Office Action Summary

10/593,368

MISKIE, MARK

DETAILED ACTION

Figure 1

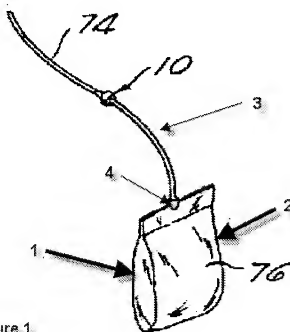
For reference Figure 1, please refer to annotated Figure 1 below

Regarding claim 1, Choksi discloses a collection bag (76 in Fig. 1) adapted for communicating with a male incontinence device (Fig. 1) capable of covering a portion of the penis, the collection bag (76 in Fig. 1) comprising:

first (1 in Fig. 1) and second (2 in Fig. 1) opposing flexible side walls joined together and forming a fluid container (76 in Fig. 1) for holding urine (see column 1, lines 45-49); and

a cylindrical bag neck (3 in Fig. 1) formed with the first (1 in Fig. 1) and second (2 in Fig. 1) side walls and defining a mouth (4 in Fig. 1) for receiving urine passed through the incontinence device (Fig. 1) and into the fluid container (76 in Fig. 1),

multiple circumferentially-spaced indexing elements (50 and 72 in Fig. 5); and

the indexing elements (50 and 72 in Fig. 5) cooperating to position the valve cap (16 in Fig. 5) relative to the incontinence device (Fig. 1), such that the check valve (54 in Fig. 4) is locatable in a single operative orientation (see Fig. 5).

For reference Figure 1 of Waters, please refer to annotated Figure 1 below.

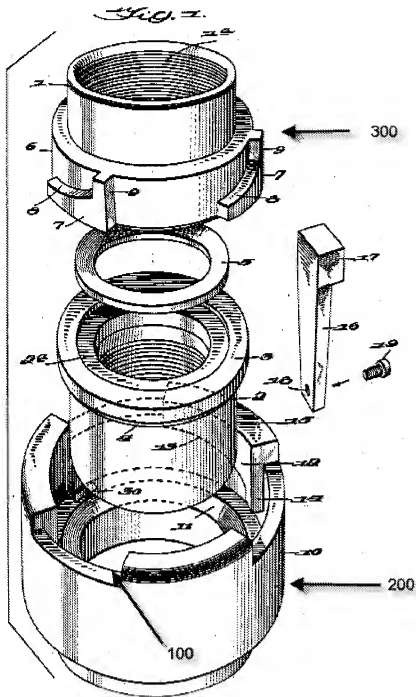
Regarding claim 3, Choski discloses a collection bag (76 in Fig. 1) with indexing elements (50 and 72 in Fig. 5) but DIFFERS in that it does not disclose the indexing

elements to be spaced-apart along an inner circumference of the connecting portion of the valve cap. Attention, however, is directed to Waters. Waters discloses an enlarged-diameter connecting portion (Waters, 10 in Fig. 1) with indexing elements (Waters, 12 in Fig. 1) to be spaced-apart along an inner circumference (Waters, 100 in Fig. 1) of the connecting portion (Waters, 10 in Fig. 1) of the valve cap (Waters, 200 in Fig. 1). Therefore, it would have been obvious to one skilled in the art at the time the invention was made to have modified Choksi to include the indexing elements to be spaced-apart along an inner circumference of the connecting portion, in view of the teachings of Waters, in order to facilitate rapid assembly and disassembly. Doing so allows for easy use of the device.

Regarding claim 13, Choksi discloses an incontinence management system but DIFFERS in that it does not include a receptacle neck with complementary indexing elements cooperating with the indexing elements on the valve cap to locate the check valve in a single operative orientation. Attention, however, is directed to Waters. Waters discloses a receptacle neck (Waters, 300 in Fig. 1) with complementary indexing elements (Waters, 9 in Fig. 1) cooperating with the indexing elements (Waters, 12 in Fig. 1) on the valve cap (Waters, 200 in Fig. 1) to locate the check valve (Waters, 4 in Fig. 1) in a single operative orientation. Therefore, it would have been obvious to one skilled in the art at the time the invention was made to have modified Choksi to include a receptacle neck with complementary indexing elements cooperating with the indexing elements on the valve cap to locate the check valve in a single operative orientation, in view of the teachings of Waters, in order to facilitate rapid assembly and

Regarding claim 15, the modified Choksi, as applied to claim 14, discloses an incontinence management system but DIFFERS in that it does not include indexing elements on the valve cap that further comprises locking tabs. Attention, however, is direct to Waters. Waters discloses indexing elements (Waters, 9 in Fig. 1) on the valve cap (Waters, 200 in Fig. 1) that further comprises locking tabs (Waters, 15 in Fig. 1). Therefore, it would have been obvious to one skilled in the art at the time the invention was made to have modified the modified Choksi to include indexing elements on the valve cap that further comprises locking tabs in order to provide a locking that is entirely within the confines of the coupling in the device. Doing so would provide an effective locking device while eliminating excess and cumbersome parts.
